### SERVICE BULLETIN MINITED

126

INSPECTION OF PORT RUDDER BAR FOR CHAFING

T67B, T67C Series, T67M, T67M-MkII, T67M200, T67M260 and T67M260-T3A

FIG 1 CORRECT CABLE ROUTING AND TYING

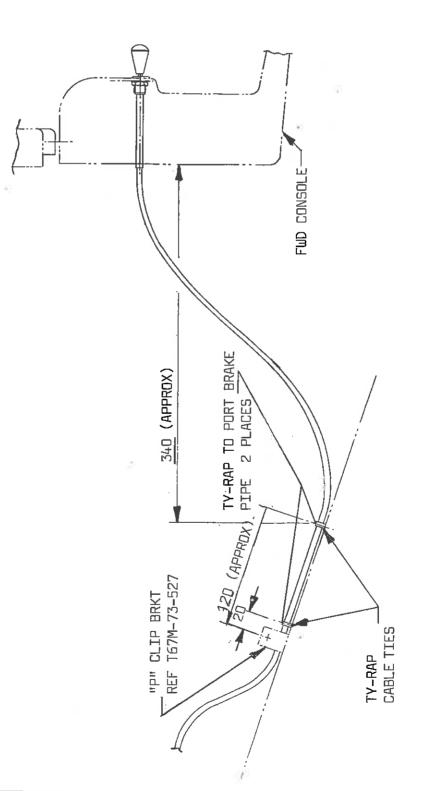
A case has been reported of the hot air control cable fouling and damaging the rudder crossbar due to poor routing.

This SB requires a one time inspection and rectification of the rudder bar and hot air cable routing.

- 1. Inspect, using a strong light and a mirror, the lower (port) rudder bar above hot air control cable for signs of chafing.
- 2. If no chafing has occurred, ensure cable routing conforms to Fig. 1.

- Should the rudder bar T67M-45-257 be damaged, ie paint removed or grooved to a depth of less that 0.1mm, the rudder bar should be deemed serviceable, repaint damage. A new cable should be fitted according to Fig. 1. Hot air cable Pt No.T67B-74-217 Pre Mod M234, T67B-74-225 Post Mod M234 applicable T67B, T67C Series, T67M, T67M-MkII and T67M200; T67G-74-205 T67M260 and T67M260-T3A aircraft.

- 4. If rudder bar T67M-45-257 is grooved to a depth of between 0 and 0.5mm, remove rudder bar, blend out groove, repaint and refit. If rudder bar is grooved to a depth greater than 0.5mm, strip down rudder bar assembly and return rudder bar to manufacturer for repair, fit replacement rudder bar. Hot air control cable should be replaced and fitted according to Fig. 1.
